8564EC-04

S E R V I C E N O T E

856xEC Series Portable Spectrum Analyzer

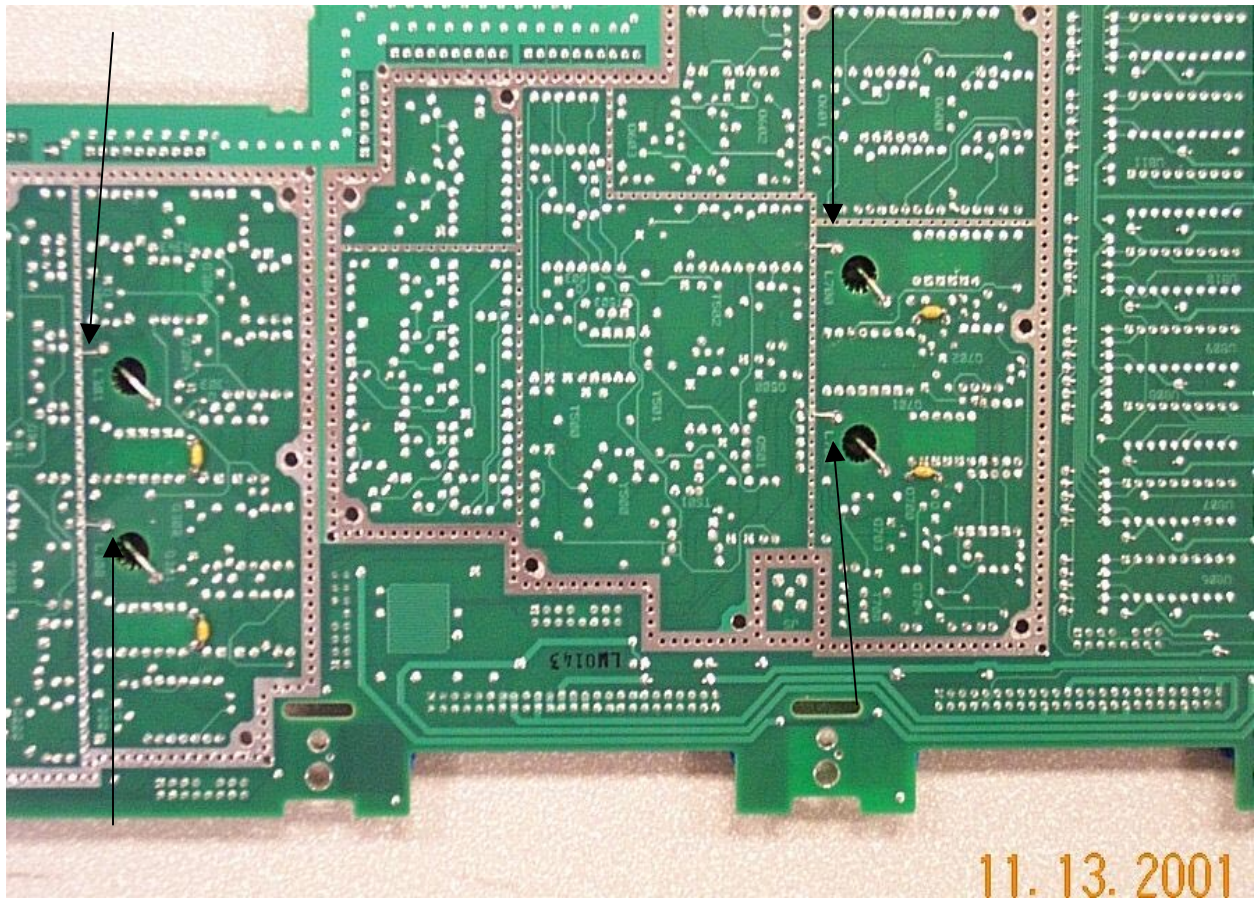
For the instruments specified above, inductors within the A5 IF assembly are not making good connections to ground thereby giving error messages related to the A4 Log Amp board. Error numbers that appear in the lower right-hand corner of the screen on account of this problem are errors 561, 562, and 565.

If the serial number of the instrument applies to the ones above, the following butch may solve the problem. Remove the shielding from the A5 IF assembly. Locate the inductors, and according to the attached photograph, insert and solder one end of the 8150-4222 wire into the hole connecting to the inductors and solder the other end to the ground plane on the front layer of the board. Do this for each inductor. See attached picture, the arrows point to where the jumpers are attached.

Add jumpers according to the picture above.
